RAMP REPORT REGION 2 ADA 2026

Route 7 – Vine Street
Belfast

CR09027

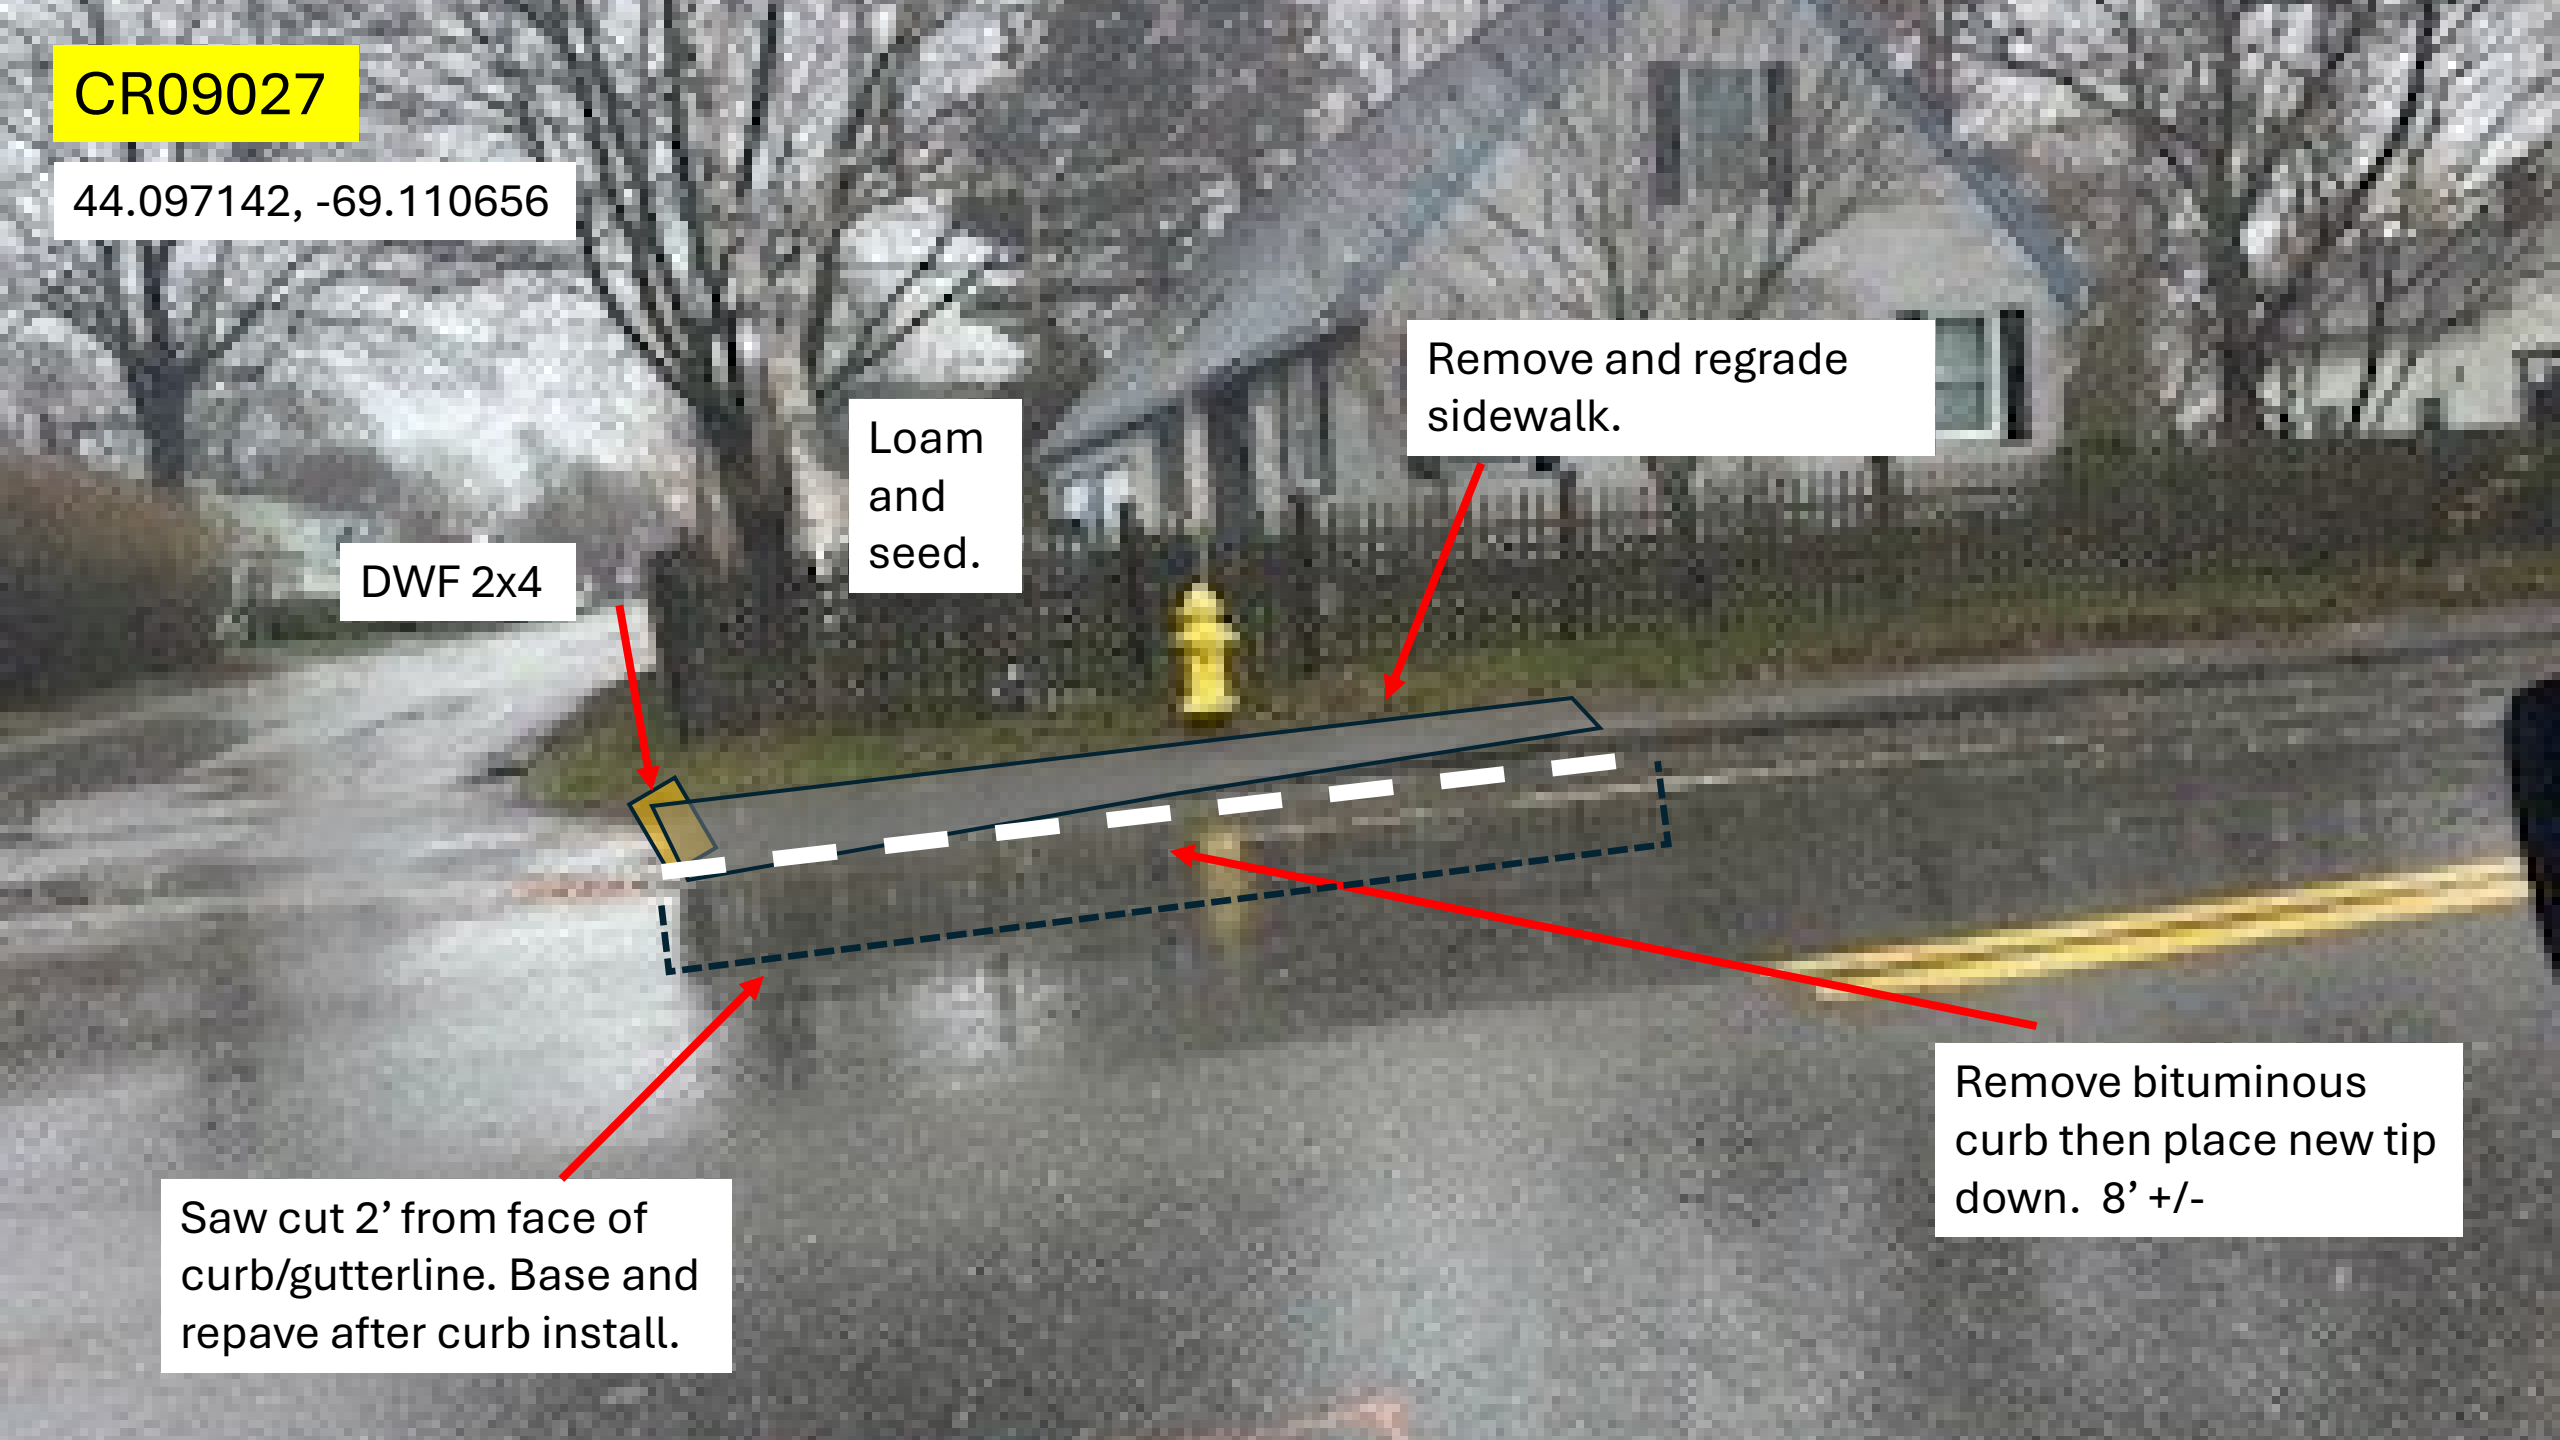
Loam
and
seed.

Remove and regrade
sidewalk.

DWF 2x4

Saw cut 2' from face of
curb/gutterline. Base and
repave after curb install.

Remove bituminous
curb then place new tip
down. 8' +/-

CR09028

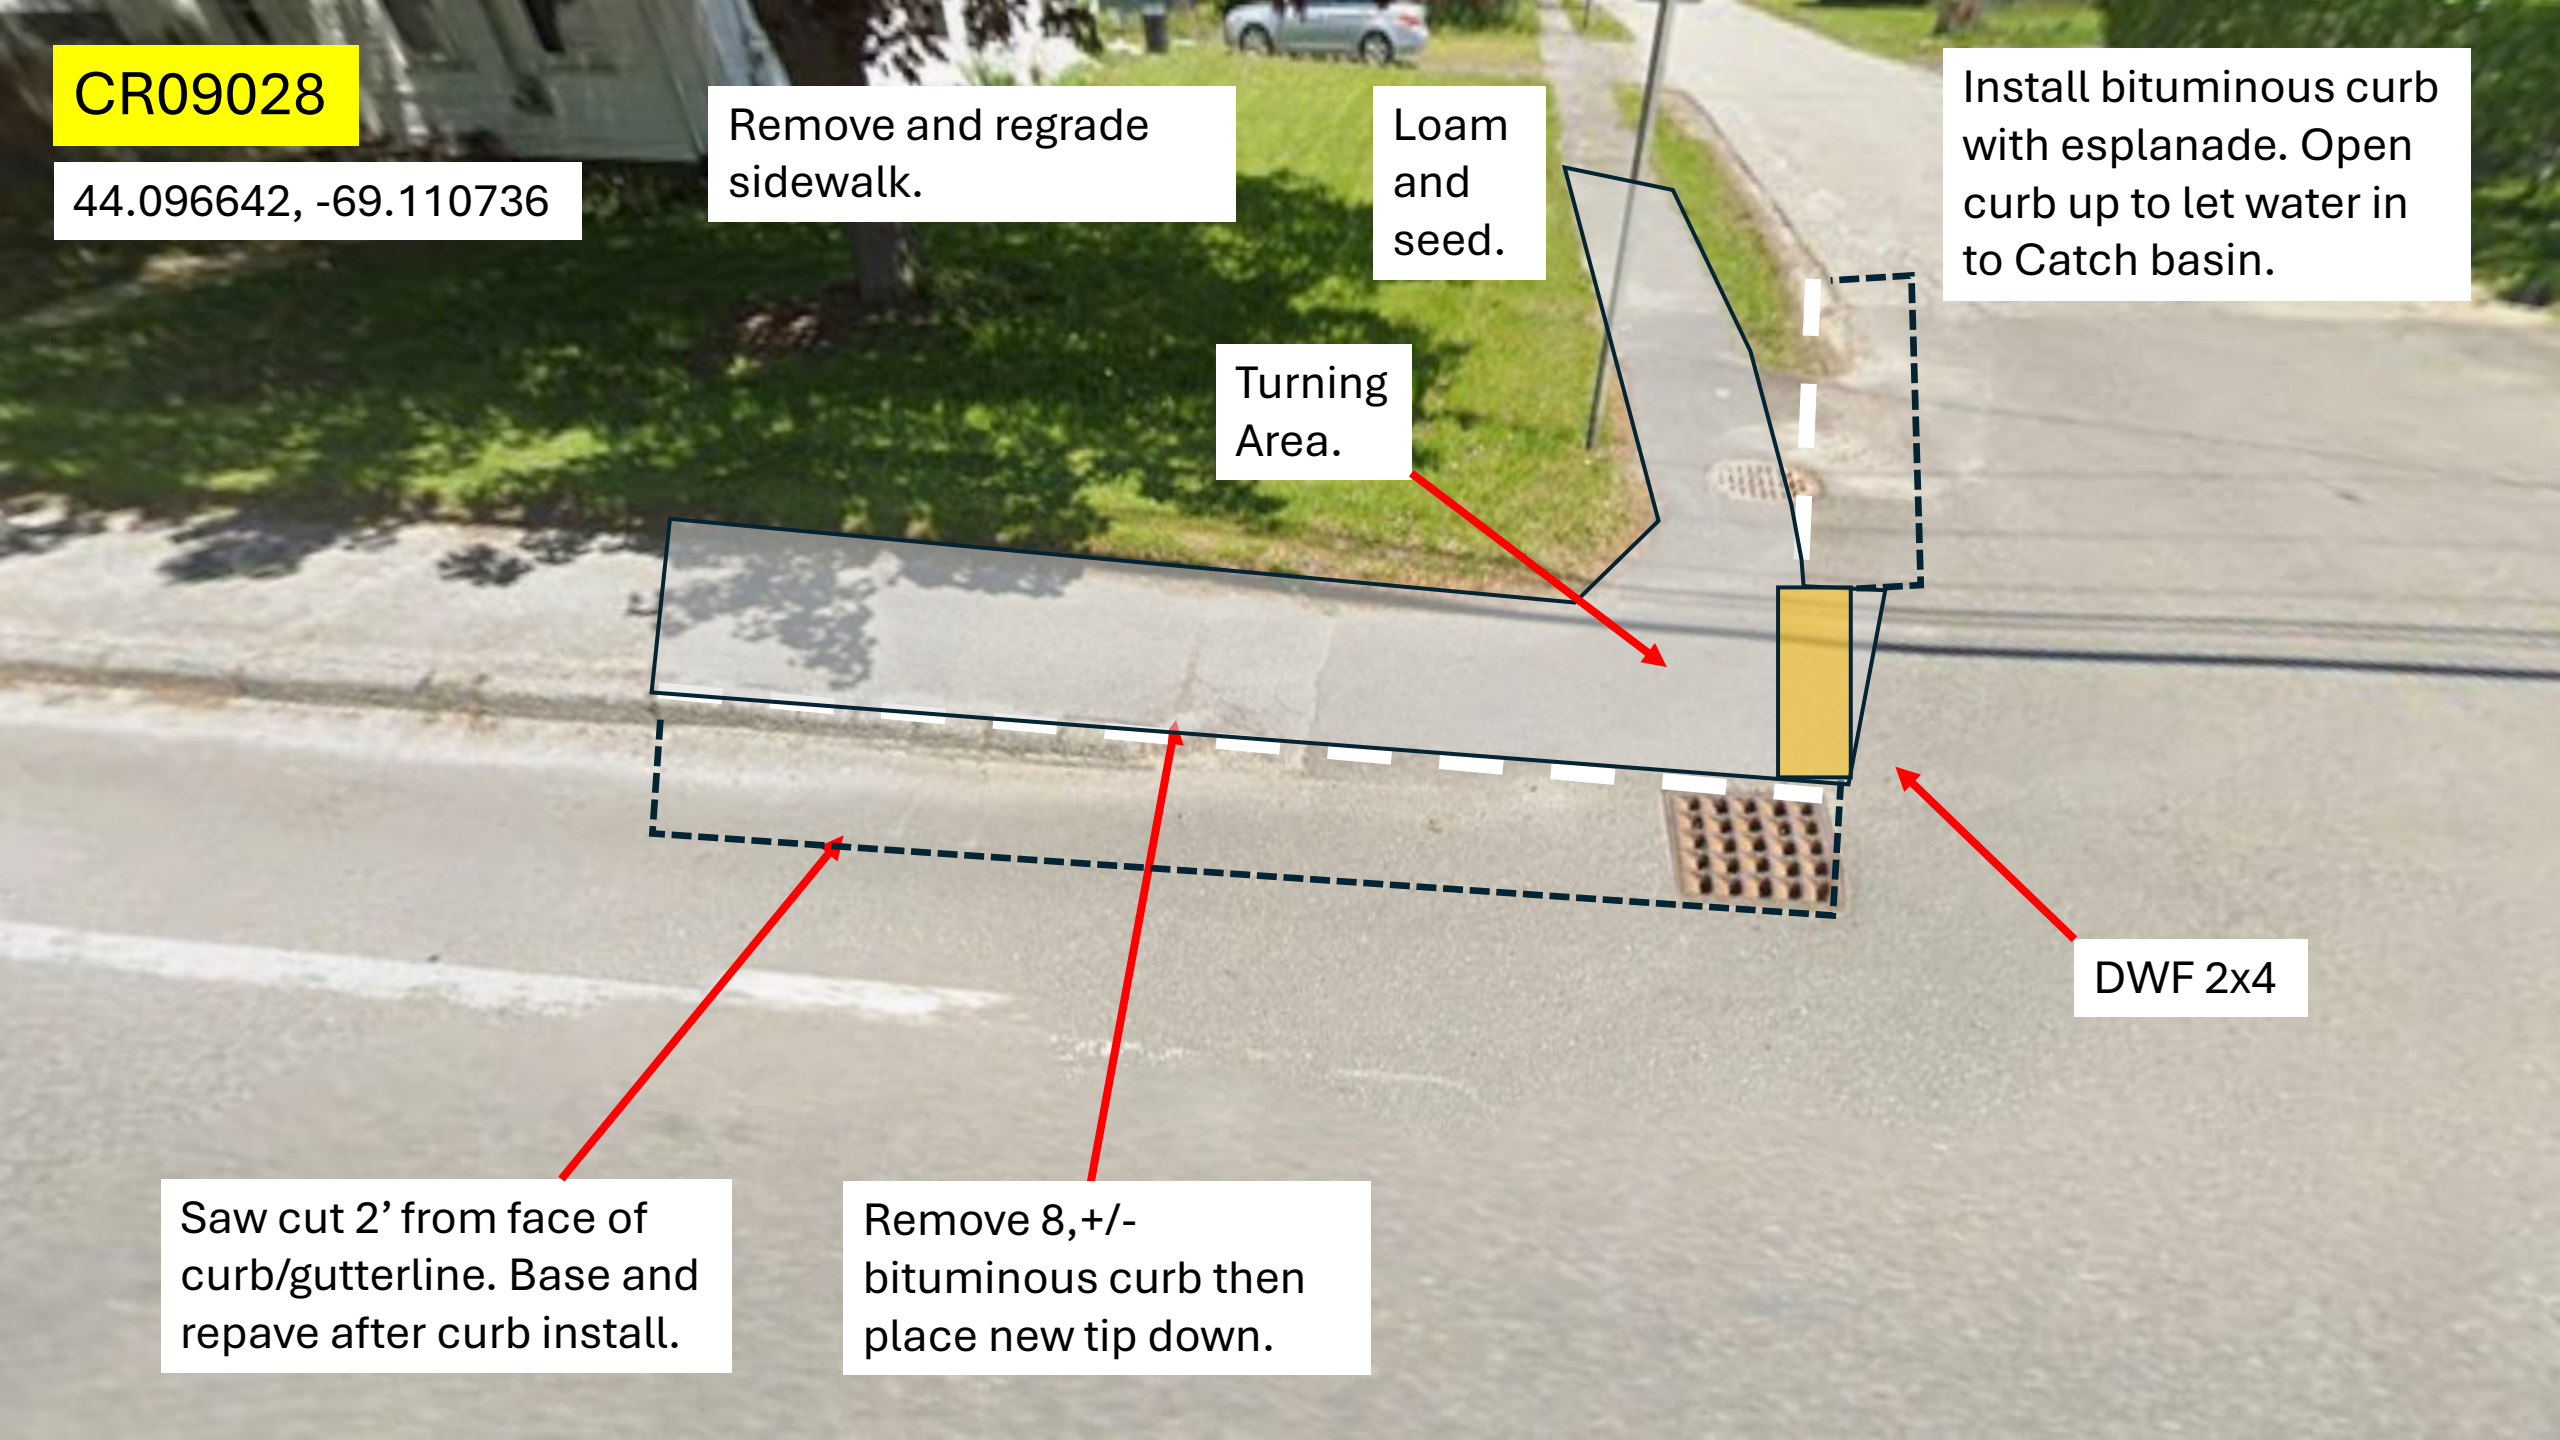
Remove and regrade sidewalk.

Loam and seed.

Install bituminous curb with esplanade. Open curb up to let water in to Catch basin.

Turning Area.

DWF 2x4

Saw cut 2' from face of curb/gutterline. Base and repave after curb install.

Remove 8, +/- bituminous curb then place new tip down.
